CITY OF ALBUQUERQUE

**RE: Advanced Auto Parts
Grading and Drainage Plan
Engineer's Stamp Date 8-17-2015 (File: H14D041)**

Based upon the information provided in your submittal received 8-18-15, the above referenced plan cannot be approved for Building Permit until the following comments are addressed:

C-102

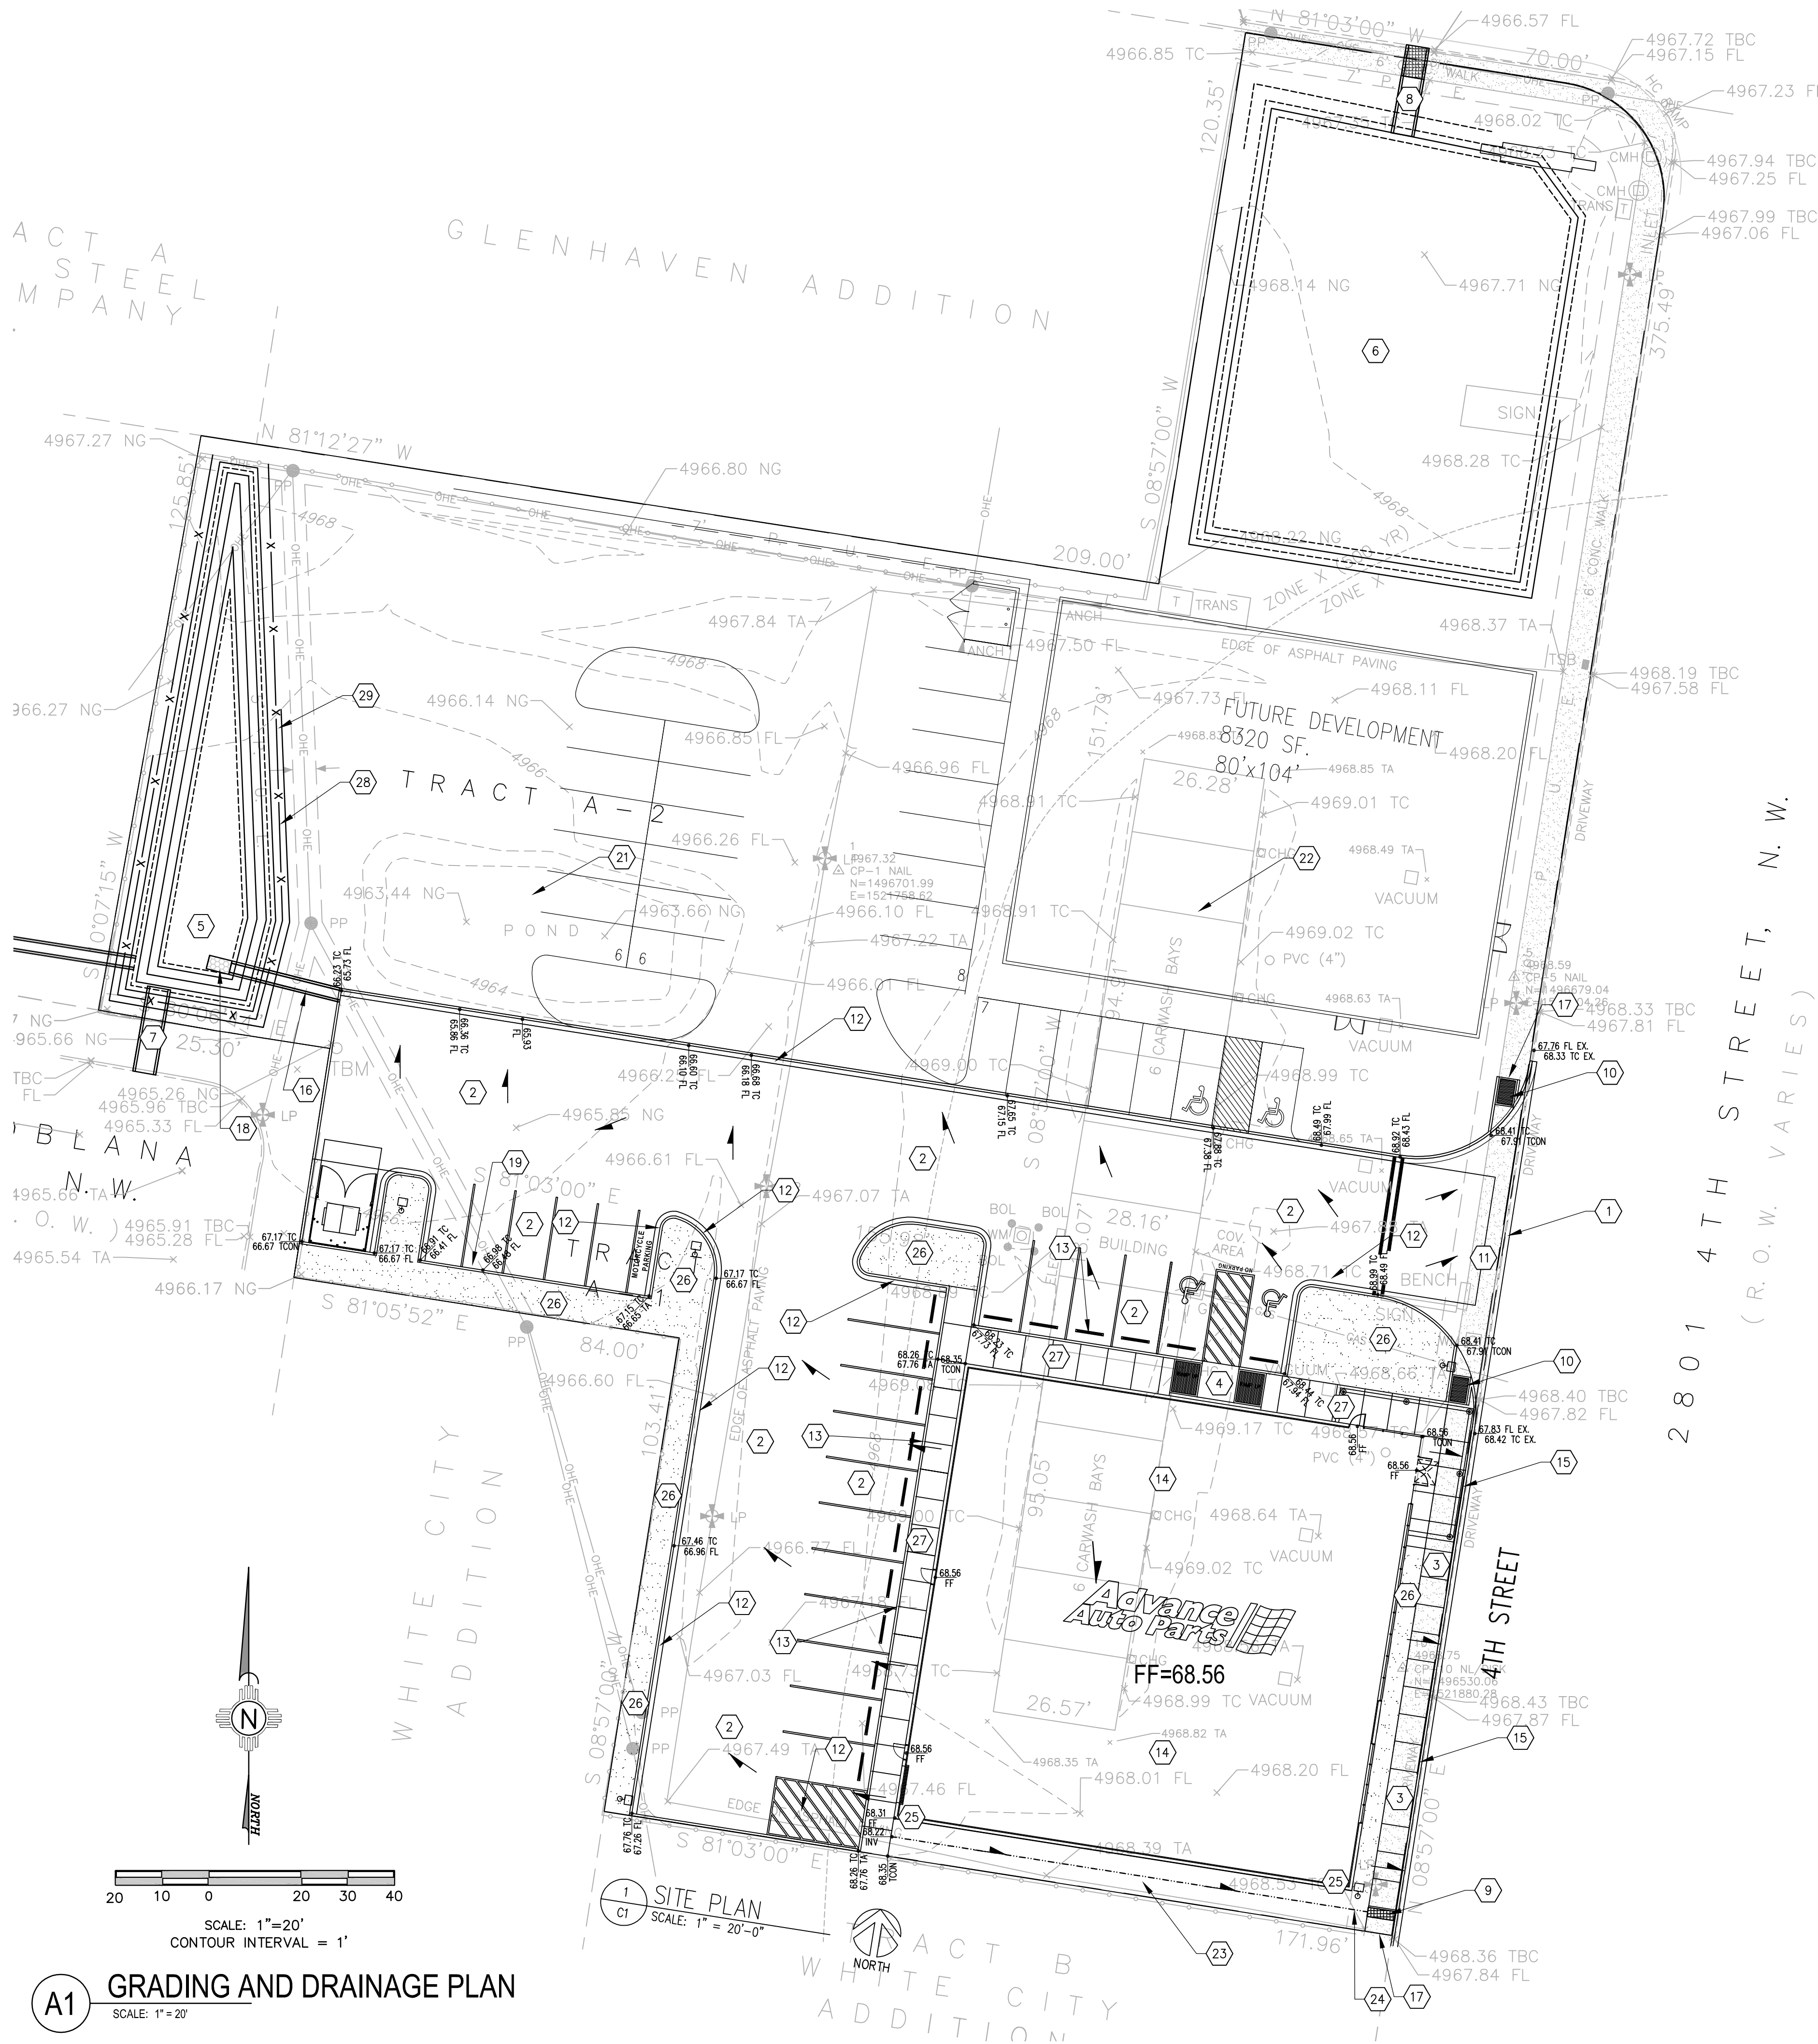
- a. Grading and Drainage plan with supporting calculation for the **Final Developed condition**. Dwg. C-102 is essentially this Final Condition Plan. However, the following needs to be corrected:

- i. Remove the Curb and Gutter separating the two properties, and show only the intended final condition.
 - ii. Show intended elevations/contours in the future parting lot

- iii. How will flows be directed to the pond in the final condition without the curb and gutter?
 - iv. Show the intended roof discharge points and direction of the future building

- v. Since full Retention ponds must retain the 100yr-10day volume, with 1 ft. of freeboard, Pond #1 is undersized.
 - vi. Future Pond #2 should be a detention pond, only retaining the First Flush and then discharging at a rate of 2.75cfs/Ac. The discharge mechanism will need to be designed.

D5 TYPICAL WATER HARVEST AREA NO. 1 SECTION DETAIL
SCALE: NOT TO SCALE

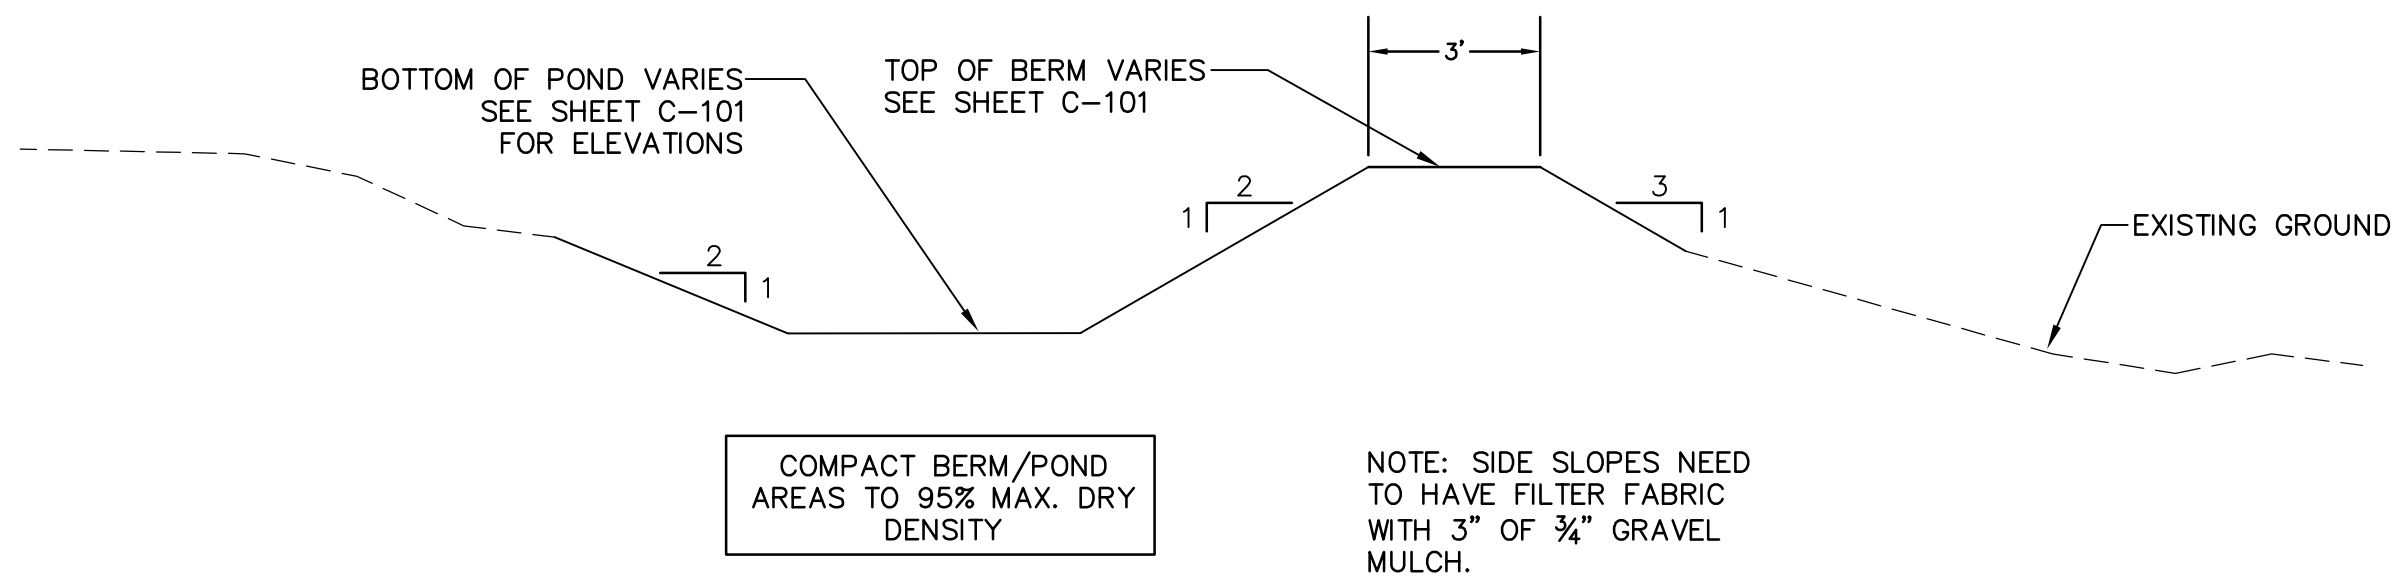
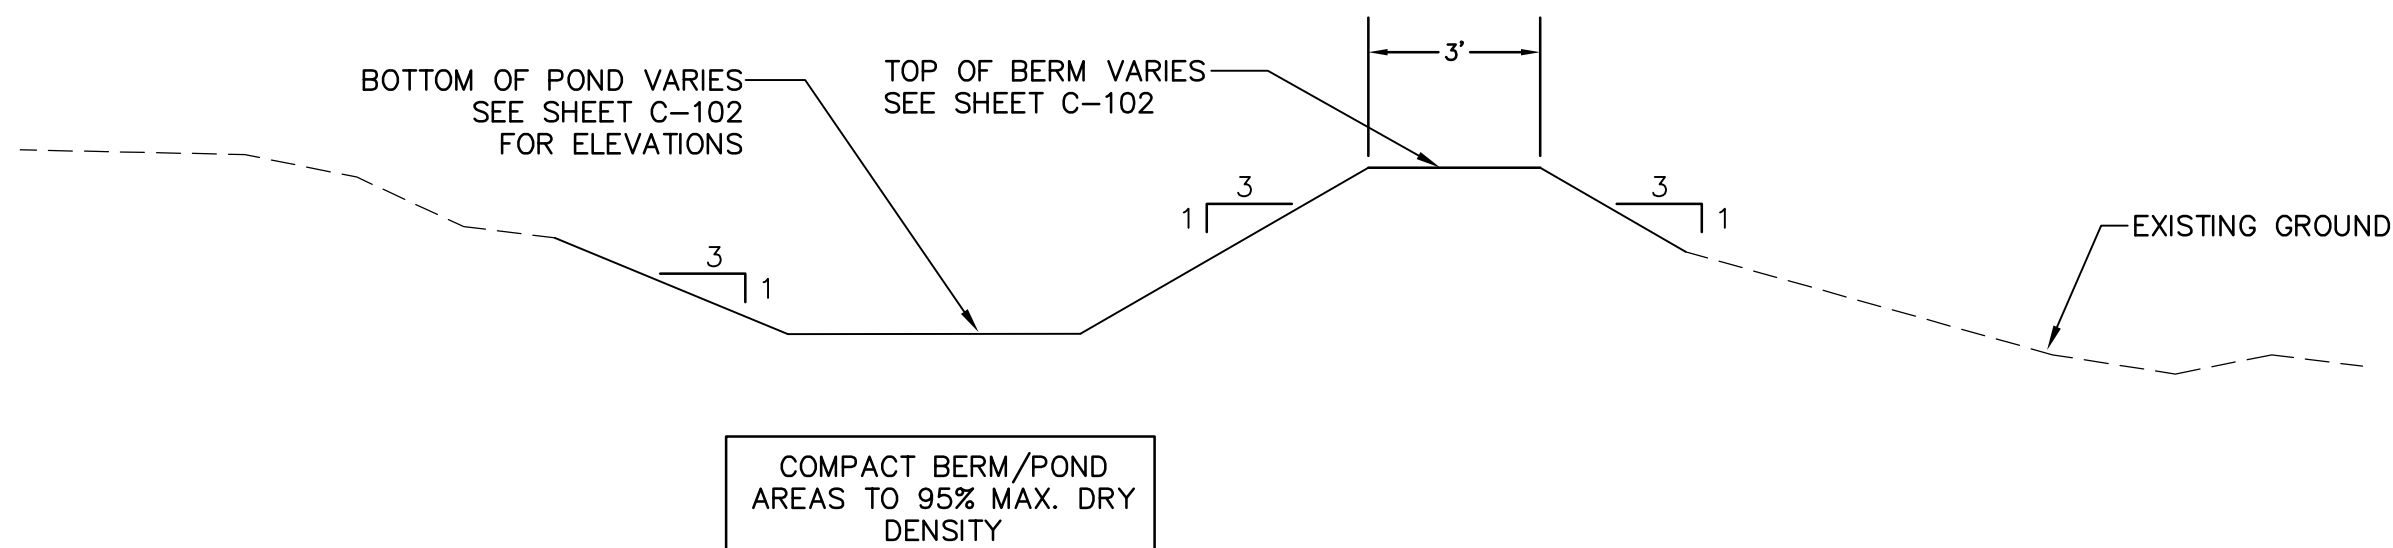
3. For both Ponds: Show contour labels, Bottom of Pond elevation, Max WSEL, Provided Volume and Required Volume. (Show this on both the Interim and Future G&D plans, as it may be different)

7. Pond #2 has a 2:1 slope. More than a 3:1 slope required slope stabilization measures. Large cobbles are typically used.
